Access Compliance Report

Public Rights-of-Way (Curb Ramps)

Intersection ID: 29698	Main Street: SIMFIELD_CHURCH_RD	Cross Street: WOODCROFT_WY	Location: SE
ADA ID: 9F6BFBBAFC0D	Ramp Type: Perp	Initial Pass/Fail: Fail	Overall Compliance: No
		Severity Score: 8.75

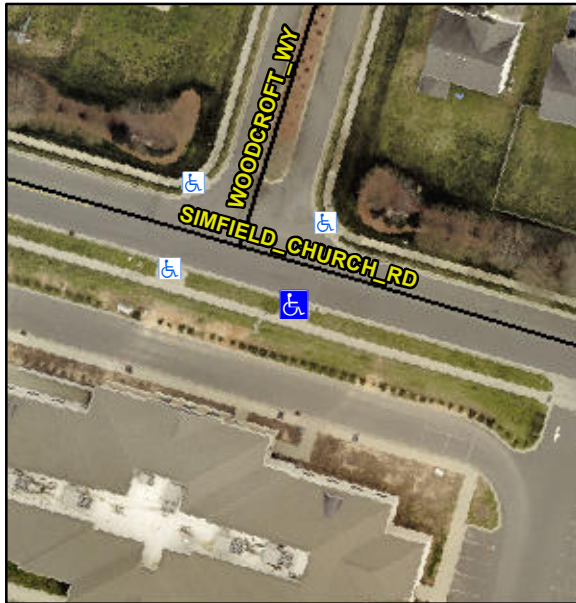
Not Found, R304.5.1

Compliance	Description	Data	Compliance	Description	Data
N/A	Ramp Length (in)	95.5	Yes	Ramp Slope (%)	7.5
No	Ramp Width (in)	47.5	Yes	Ramp XSlope (%)	0.7
N/A	Flare Type LT	N/A	N/A	Flare Type RT	N/A
N/A	Flare Slope LT (%)	N/A	N/A	Flare Slope RT (%)	N/A
N/A	Flare Traversable LT?	N/A	N/A	Flare Traversable RT?	N/A
N/A	Landing Length (in)	N/A	N/A	DWS Provided?	N/A
N/A	Landing Width (in)	N/A	N/A	DWS Contrast?	N/A
N/A	Landing Slope (%)	N/A	N/A	DWS Length (in)	N/A
N/A	Landing X Slope (%)	N/A	N/A	DWS Full Width?	N/A
N/A	Landing Curb? (Y/N)	N/A	N/A	DWS Offset (in)	N/A
N/A	Shared Landing?	N/A			
N/A	Gutter Ponding?	N/A	N/A	Gutter Slope (%)	N/A
N/A	Gutter Lip Ht (in)	N/A	N/A	Gutter X Slope (%)	N/A
N/A	Painted X Walk1?	No	N/A	Painted X Walk2?	N/A
	X Walk 1 Direction	To N		X Walk 2 Direction	N/A
N/A	X Walk 1 Width (in)	N/A	N/A	X Walk 2 Width (in)	N/A
	X Walk 1 Slope (%)	4.3		X Walk 2 Slope (%)	N/A
	X Walk 1 X Slope (%)	2.3		X Walk 2 X Slope (%)	N/A

Remove & Replace Entire Ramp.
